**PLAT COMMITTEE**

**January 14, 2026**

**Case Number:** 2025-PLT-081  
**Address:** 1438 North Park Avenue (approximate address)  
**Location:** Center Township, Council District #13  
**Zoning:** D-8 (ONS – IHPC)  
**Petitioner:** Timothy Joseph Graham, Trustee T Graham 2017 Revocable Trust,  
by John Cross  
**Request:** Approval of a Subdivision Plat, to be known as Replat of a Part of  
Lot 7 in Bradshaw and Butler's Addition to College Corner, dividing  
0.12-acre into two single-family attached lots.  
**Waiver Requested:** None  
**Current Land Use:** Two-family attached dwelling  
**Staff Reviewer:** Robert Uhlenhake, Senior Planner

## PLAT SURVEY – SITE PLAN

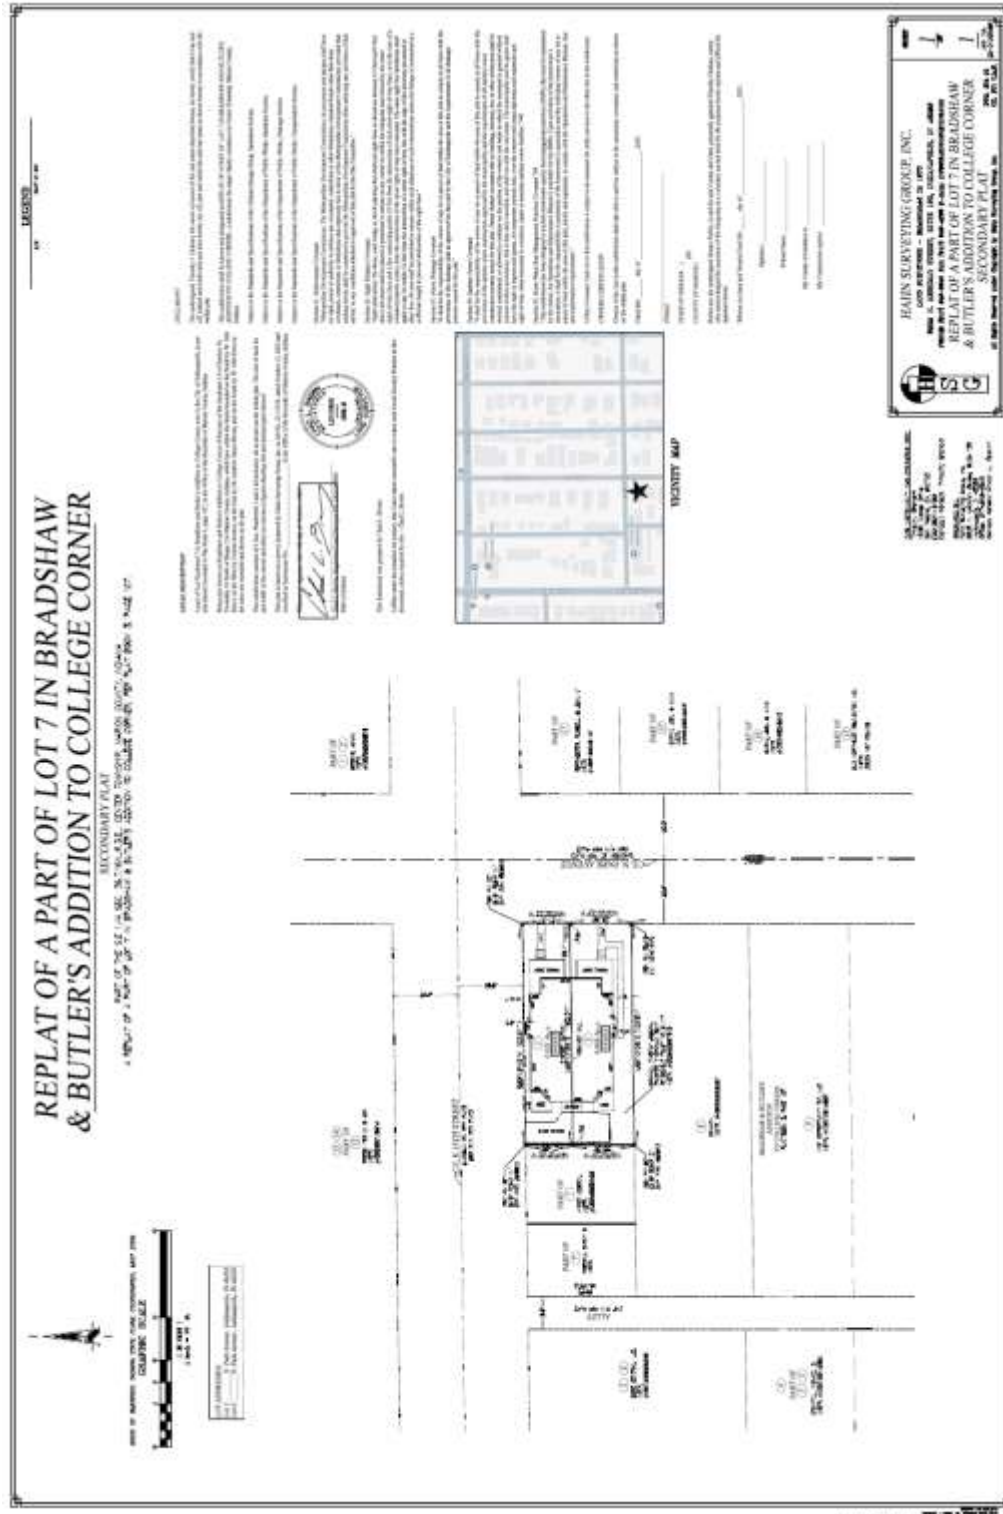
Staff recommends that the Plat Committee **approve** and find that the plat, file-dated October 22, 2025, complies with the standards of the Subdivision regulations, subject to the following conditions:

This site is zoned D-8 and is developed with a two-family dwelling. The proposed plat would subdivide the property into two (2) lots. Lots One and Two would each contain half of the two-family dwelling with the lot line following the common wall and continuing through to the rear of the lot. The subject site has been developed with a two-family dwelling since at least 1915 as shown on the historic Sanborn map below. This replat would allow the property owner to sell each of the parcels individually, rather than as one (1) parcel, with minimal impact on the surrounding property owners.
